NOTICE OF DECISION

RE: Planning Commission decision to recommend City Council approval of the Westside Refinement Plan and accompanying implementation measures with modification to the proposal

City File Number: 311-17-000013-PLNG

**Planning Commission Findings and Decision Number 2017-09
Recommendation to Adopt Westside Refinement Plan and Accompanying
Implementation Measures
File Number 311-17-000013-PLNG**

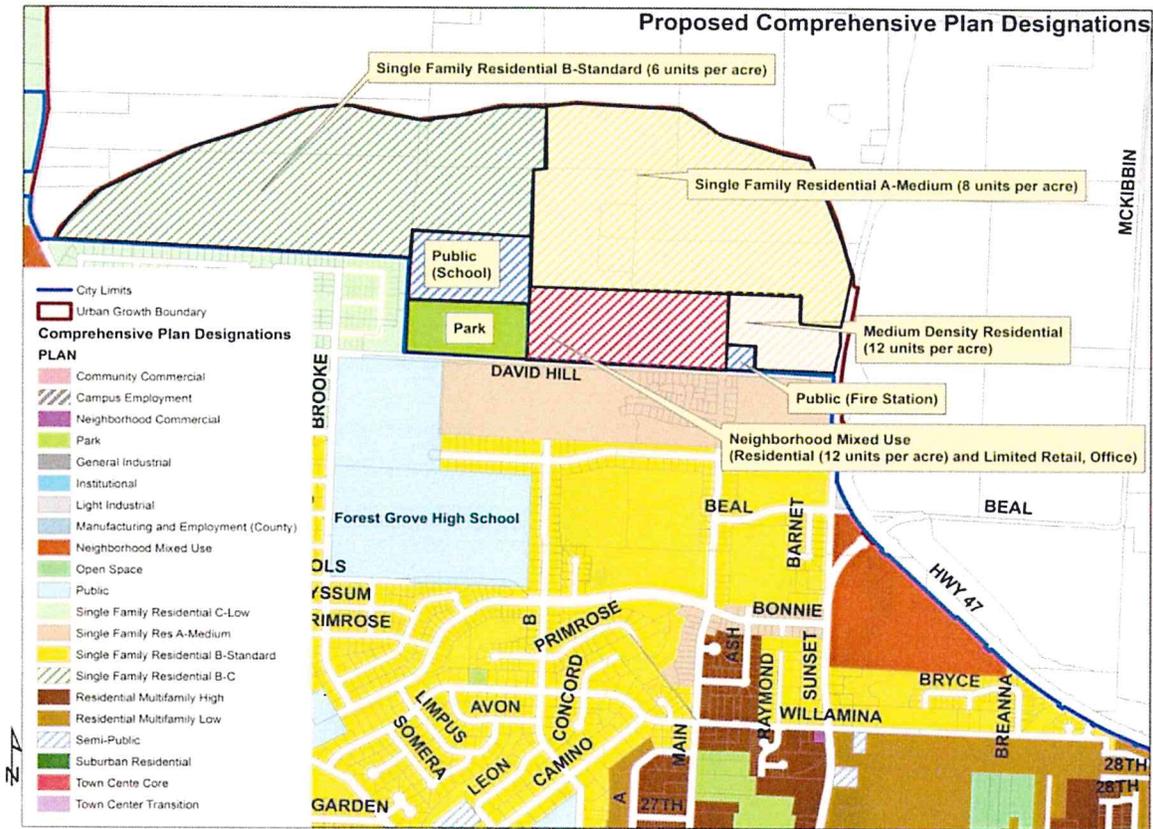
Section 3: The Planning Commission recommends approval of the following amendments to the Comprehensive Plan Map for the new urban growth boundary area north of David Hill Road, west of Highway 47 and east of Thatcher Road. No Comprehensive Plan Map amendments are recommended for the area west of Thatcher Road.

From	To	Gross Acres
Washington County Future Development-20 acre min.	A-Medium (8.95 dwellings/net acre)	86.18
Washington County Future Development-20 acre min.	B-Standard (6.22 dwellings per net acre)	98.62
Washington County Future Development-20 acre min.	Medium Density Residential (12 dwellings per net acre)	10.82
Washington County Future Development-20 acre min.	Neighborhood Mixed Use (12 dwellings per net acre)	24.63

Washington County Future Development-20 acre min.	Public (School)	10.00
Washington County Future Development-20 acre min.	Public (Fire Station)	2.40
Washington County Future Development-20 acre min.	Park	6.00

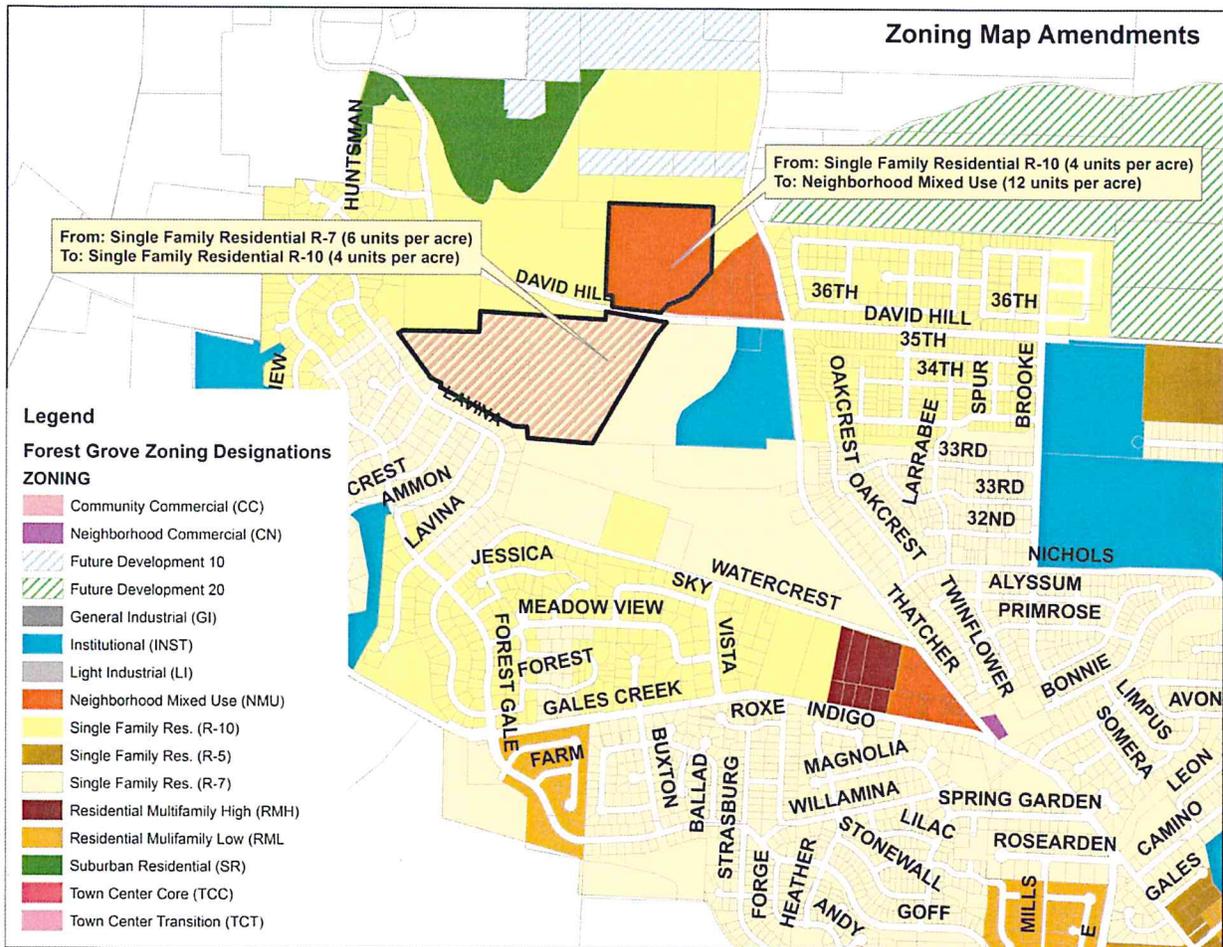
Section 4: The Planning Commission recommends the following amendments to the Zoning Map for the area west of Thatcher Road. No zoning map amendments are recommended for the new urban growth boundary area north of David Hill Road, west of Highway 47 and east of Thatcher Road.

From	To	Gross Acres
R-7 (6.22 dwellings per net acre)	R-10 (4.35 dwellings per net acre)	36.96
R-10	NMU (Neighborhood Mixed Use)	20.67

The Planning Commission recommends the change from R-7 zoning to R-10 for a portion of the area south of David Hill Road to reflect constraints to development documented in the Geological and Geotechnical Report, February 2015, prepared by PBS Engineering and Environmental.

The Planning Commission recommends the change from R-10 to NMU for the Nixon Property (Washington County Map and Tax Lot Number 1N4260002602) in order to zone the property consistent with the corresponding NMU designation shown on the Comprehensive Plan Map.

Recommended amendments to Transportation System Plan Figure 8-1

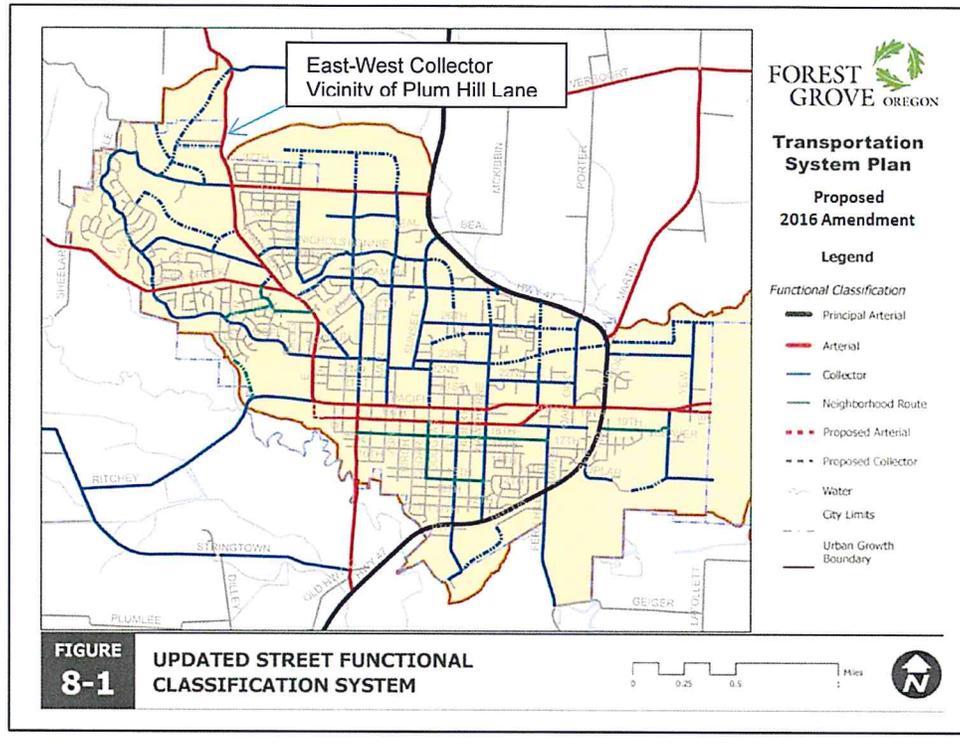
Section 6: The Planning Commission recommends the following amendments to the Forest Grove Transportation System Plan to implement the Westside Refinement Plan:
